Core Bus Corridor 15: Blackrock to Merrion - Preliminary Submission

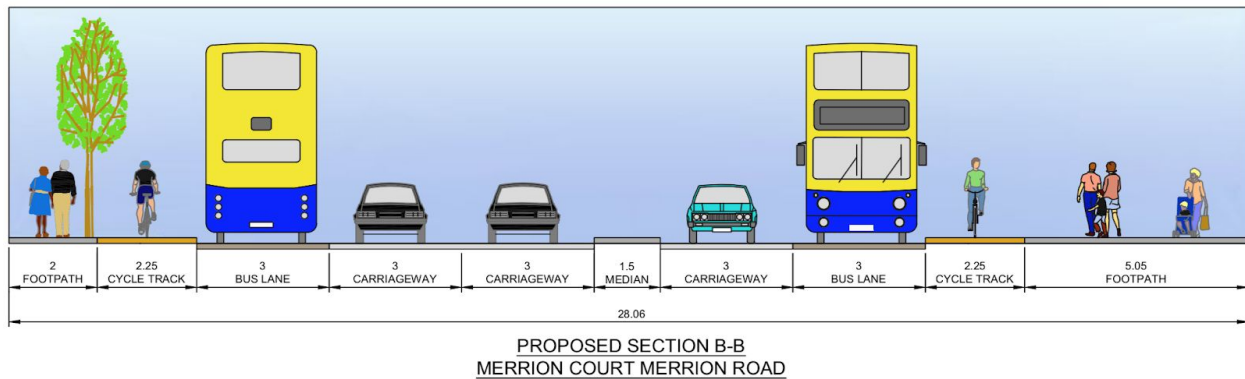
Bus stop bypasses for cyclists should be the norm as part of these designs. This is not currently the case for all bus stops. Some are and some aren't. In some cases it is a matter of reviewing bus stop locations, in others it is a matter of using the full available width.

There is a strong case to be made for the rationalisation of bus stop locations. We strongly urge the review of bus stop locations and frequency. This will ensure greater efficiency of the bus service but also allow for greater consideration of the preferred bus stop bypass design for safety of all commuters. The rationalising of bus stop locations has been carried out with great effect in the Clontarf to City Centre Cycle Route and we recommend that project as a reference tool for Bus Connects.

Extract of the Sandymount to Blackrock Public Consultation, October 2016, showing 2.25m one-way cycle tracks

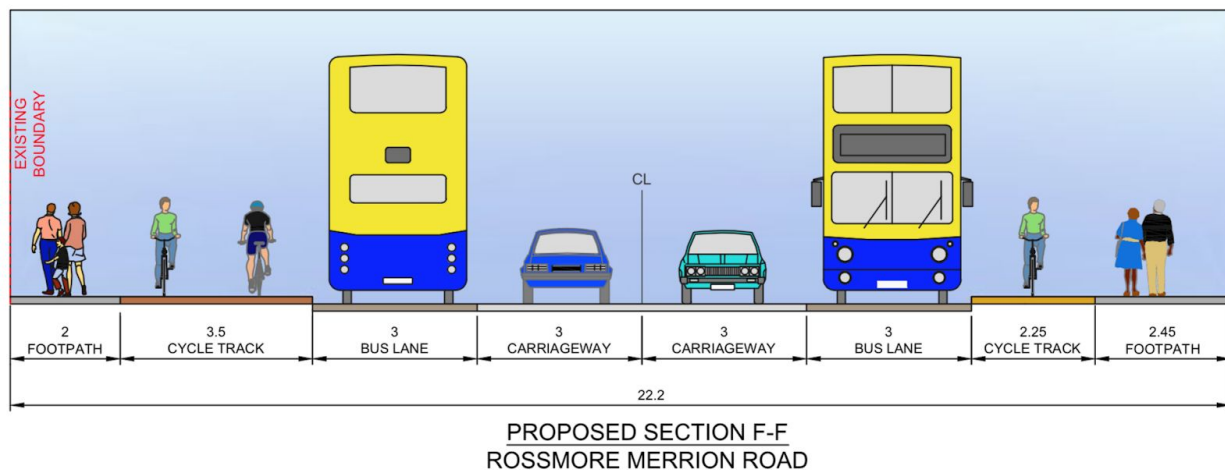
These proposals are an altered version of the Sandymount to Blackrock Cycle Scheme that the NTA put out to public consultation in October 2016. Those proposals included higher-quality cycle proposals than this Core Bus Corridor. The one way cycle tracks in that scheme were 2.25m wide where possible in many locations. Given that this is Primary Route 13A of the GDA Cycle Network Plan, the one way cycle track should aim to be more than 2m, where possible. It is requested that the national cycle manual advice - <https://www.cyclemanual.ie/manual/thebasics/width/> - is followed in this case and the one way cycle tracks are minimum 2.5m in width.

Extract of the Sandymount to Blackrock Public Consultation, October 2016, with continuous dedicated cycle facilities

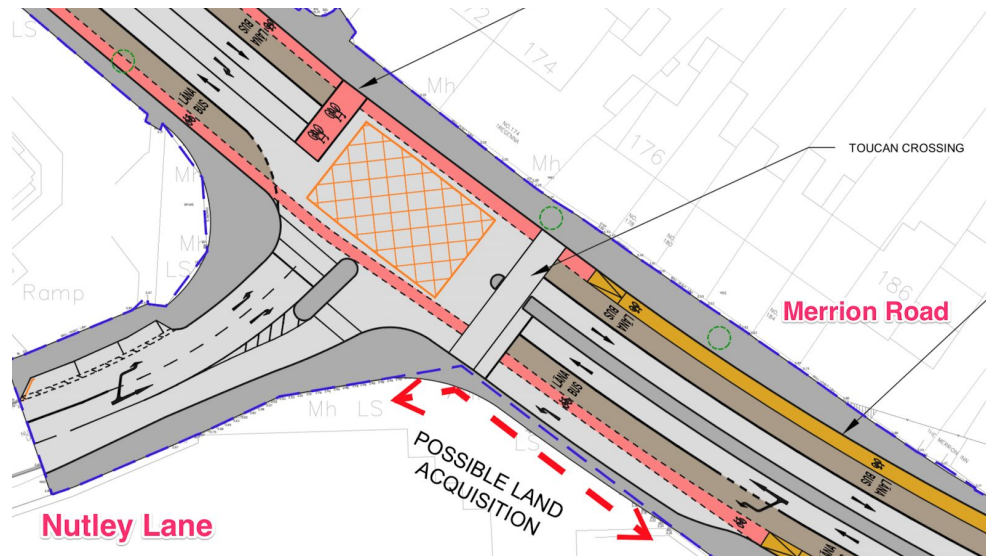
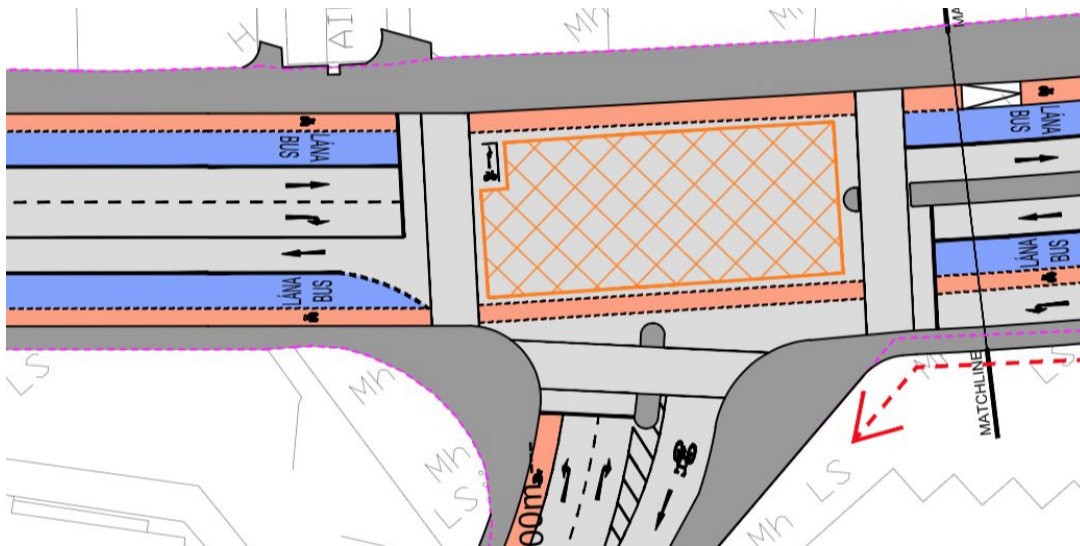
Although the Nutley Lane Junction is just outside this CBC on CBC14: UCD we will comment on it here too. The previous public consultation and the feasibility designs from AECOM included continuous dedicated cycle lanes through the junction.

Extract of CBC14: UCD public consultation document showing loss of the outbound dedicated cycle facility in order to make space for a bus priority light

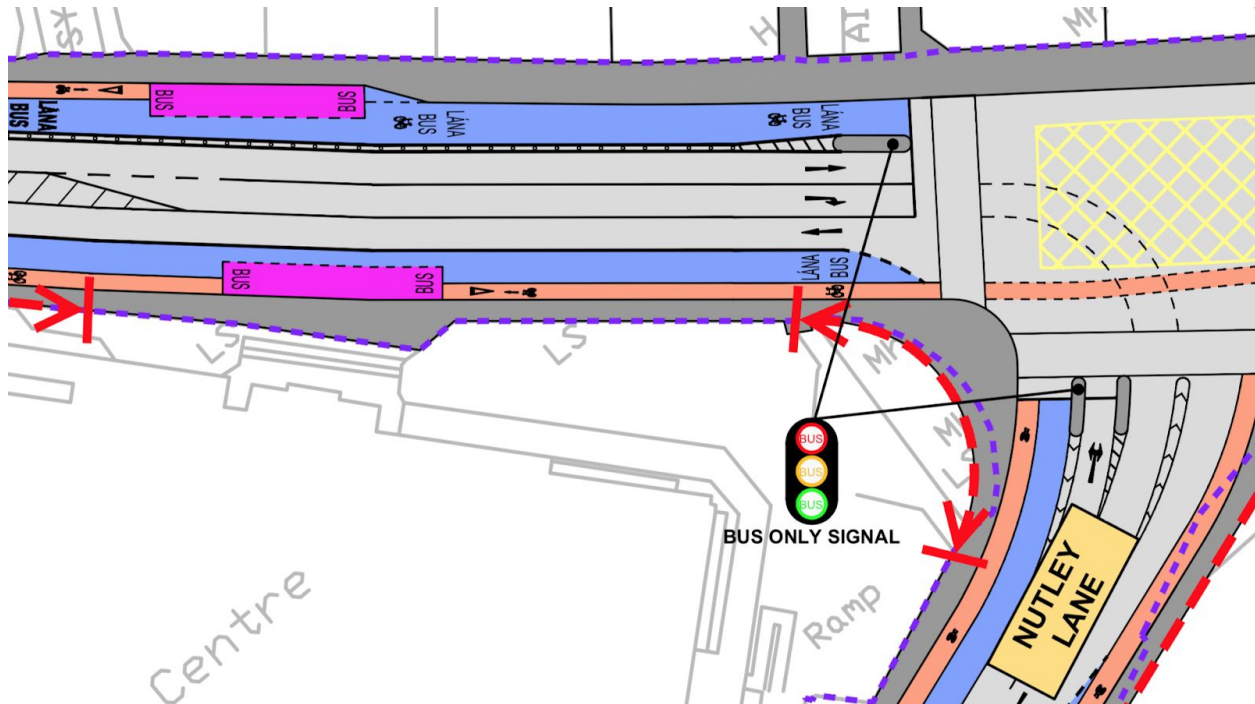
These dedicated cycle facilities have been compromised for a traffic island for bus priority lights. We understand the need for bus priority lights for right turning buses, however, it must not come at the cost of dedicated cycle facilities at this location.

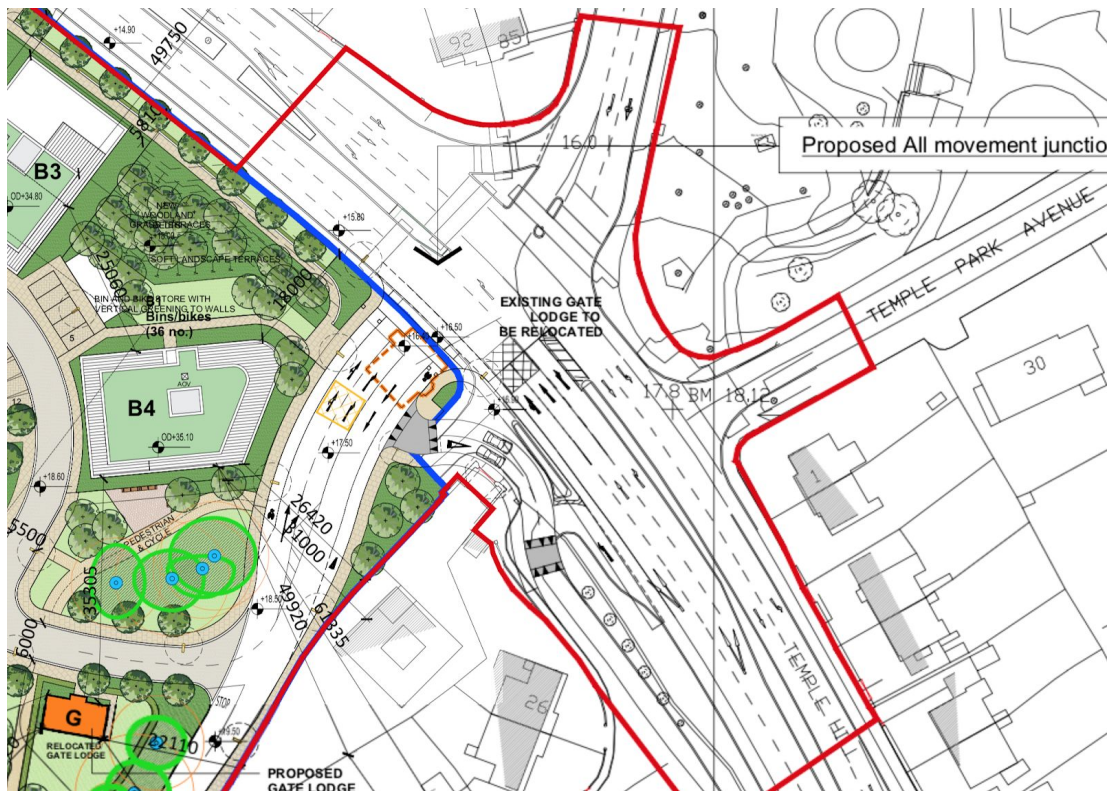
We note the proposed new bus stop locations on Map 11. The proposed indented bus stop is unusual. Why is an indented bus stop proposed at this location? Instead of an indented bus stop this could be an island bus stop instead.
